**WHITEMARSH TOWNSHIP
SHADE TREE COMMISSION MEETING AGENDA
APRIL 7, 2026 AT 6:30 PM (IN-PERSON)**

- Grading Permit # 2026-03: Philadelphia Cricket Club; 6025 W Valley Green Road; Replacement of Existing Paver Walk & Drainage at Entry; Small Addition (Keg Enclosure)
- Grading Permit # 2026-05: Sara McMenamin; 4034 Kottler Drive; Construct Single-Family Dwelling
- Grading Permit # 2026-06: Mark Barrett; 4 Mimosa Circle; Detached Garage, Driveway Extension, & Associated Improvements

GRADING PERMIT PLANS FOR PHILADELPHIA CRICKET CLUB CLUBHOUSE IMPROVEMENTS

Project: **PHILADELPHIA CRICKET CLUB CLUBHOUSE IMPROVEMENTS**
 FLOURTOWN
 MONTGOMERY COUNTY PENNSYLVANIA
 Drawing Title: **DEMOLITION PLAN**

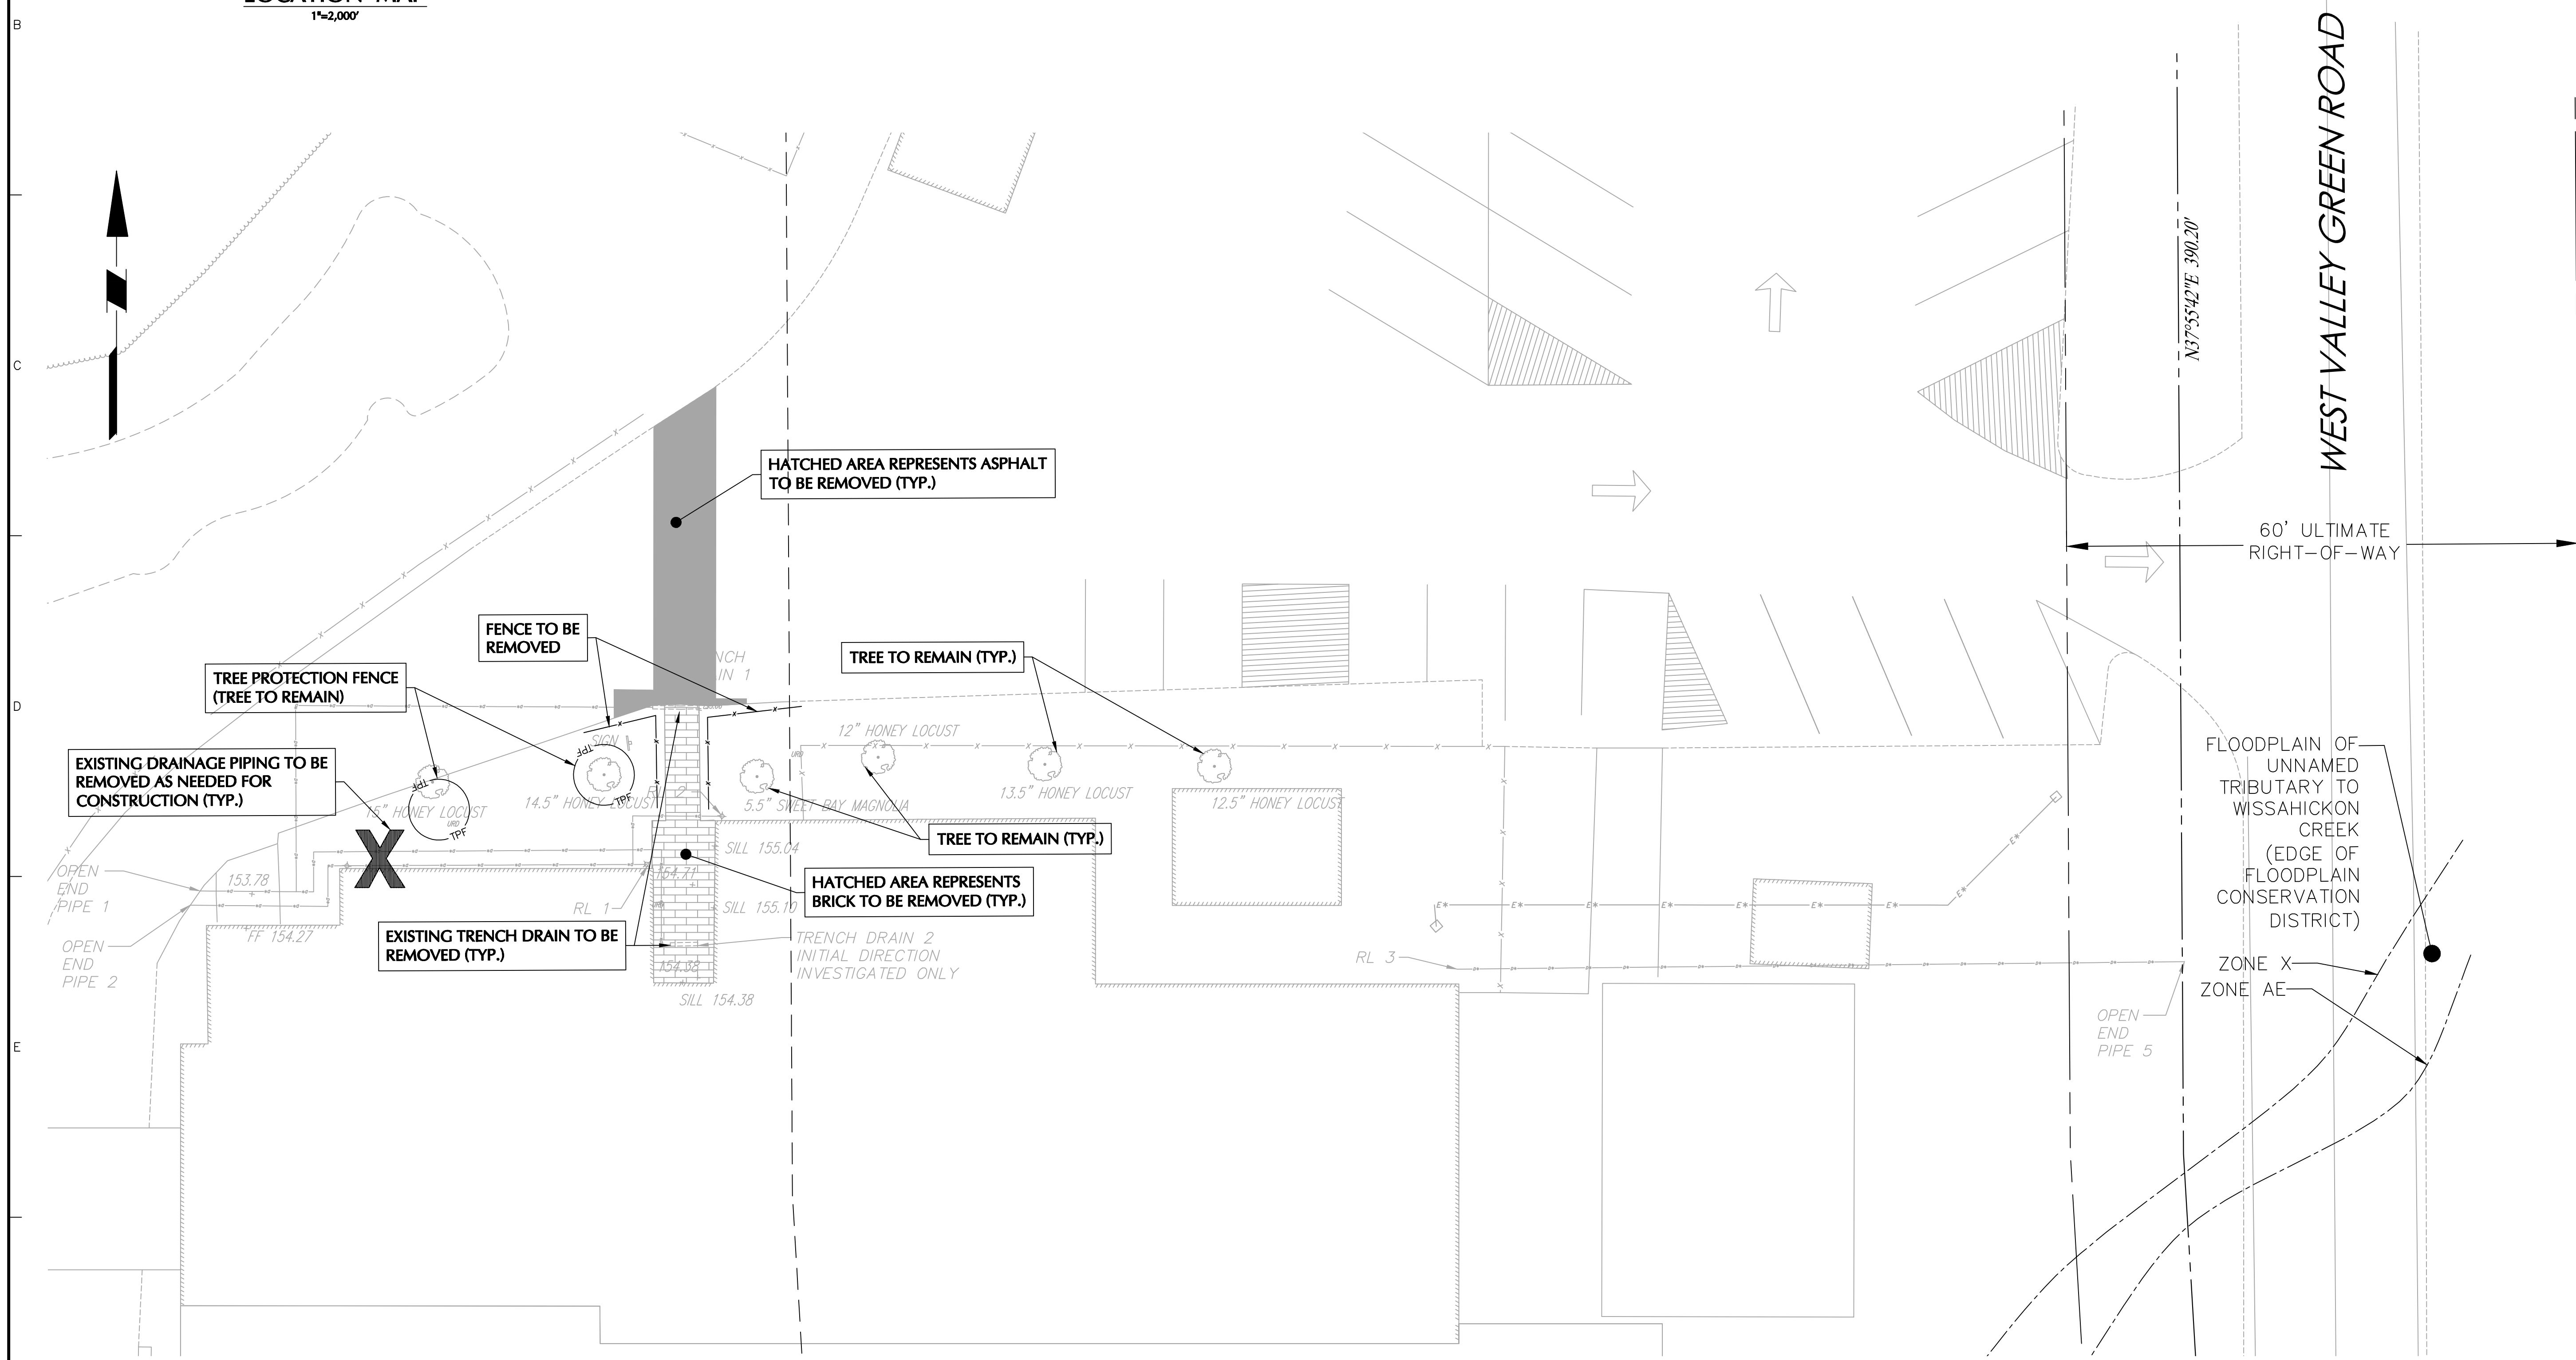
3. Section 55-4(C)(4)(b). The tree protection fencing shown on LP-101 does not appear to be consistent with those shown on Sheet CD-101. Tree Protection fencing must also be shown on Sheet CE-101. All tree protection fences must be shown encompassing the dimension of each root protection zone as established by one of the following two means, whichever is greater:
 - i. Calculated at 1.25 feet (radius) per one inch of (DBH) diameter breast height.
 - ii. A circle with a radius extending from a tree's trunk to a point no less than the furthest crown dripline.
